McCULLOCH SERVICE BULLETIN

NO. 1582

SUBJECT Advance Idle Screw

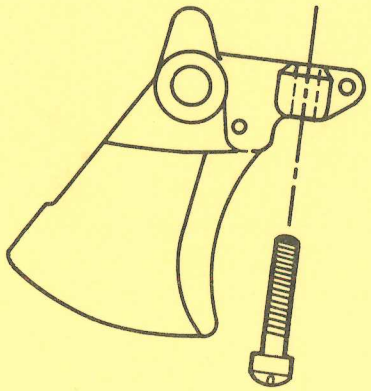
Advance Idle Screw, P/N 110668, is the new service replacement for Screw, P/N 110537. The change is effective on all model saws that are equipped with Throttle Latch, P/N 85451.

Screw, P/N 110668, is 1/8" longer than Screw, P/N 110537. The increased screw length provides a greater range of trigger adjustment and assures proper starting speed.
